Access Compliance Report

Public Rights-of-Way

(Curb Ramps)

Intersection ID: 9440	Main Street: BRADFORD_DR	Cross Street: EDGEWOOD_RD	Location: E
ADA ID: D3491506B9F7	Ramp Type: Perp	Initial Pass/Fail: Fail	Overall Compliance: No
Severity Score: 12.5			
Codes/Mitigation Info/Possible Solution		Field Measurements/Component Compliance

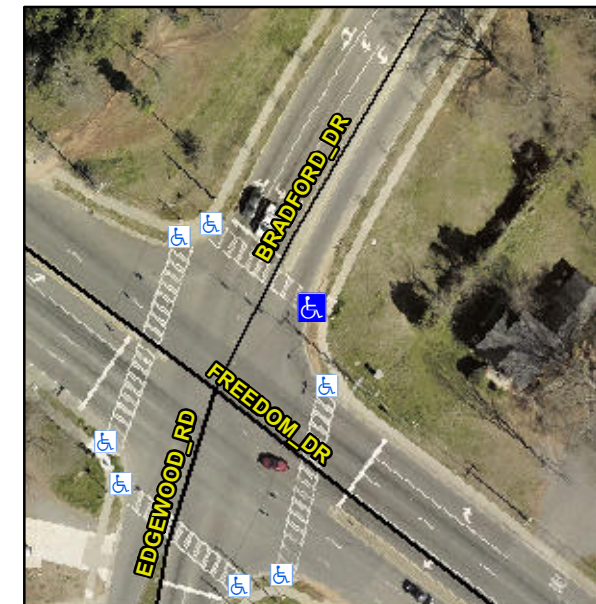
Not Found, R304.2.2

Compliance	Description	Data	Compliance	Description	Data
N/A	Ramp Length (in)	53.0	No	Ramp Slope (%)	9.9
Yes	Ramp Width (in)	48.0	Yes	Ramp XSlope (%)	0.5
N/A	Flare Type LT	N/A	N/A	Flare Type RT	N/A
N/A	Flare Slope LT (%)	N/A	N/A	Flare Slope RT (%)	N/A
N/A	Flare Traversable LT?	N/A	N/A	Flare Traversable RT?	N/A
N/A	Landing Length (in)	N/A	N/A	DWS Provided?	N/A
N/A	Landing Width (in)	N/A	N/A	DWS Contrast?	N/A
N/A	Landing Slope (%)	N/A	N/A	DWS Length (in)	N/A
N/A	Landing X Slope (%)	N/A	N/A	DWS Full Width?	N/A
N/A	Landing Curb? (Y/N)	N/A	N/A	DWS Offset (in)	N/A
N/A	Shared Landing?	N/A			
N/A	Gutter Ponding?	N/A	N/A	Gutter Slope (%)	N/A
N/A	Gutter Lip Ht (in)	N/A	N/A	Gutter X Slope (%)	N/A
N/A	Painted X Walk1?	Yes	N/A	Painted X Walk2?	N/A
	X Walk 1 Direction	To NW		X Walk 2 Direction	N/A
N/A	X Walk 1 Width (in)	116.0	N/A	X Walk 2 Width (in)	N/A
	X Walk 1 Slope (%)	2.9		X Walk 2 Slope (%)	N/A
	X Walk 1 X Slope (%)	0.0		X Walk 2 X Slope (%)	N/A

Remove & Replace Entire Ramp.
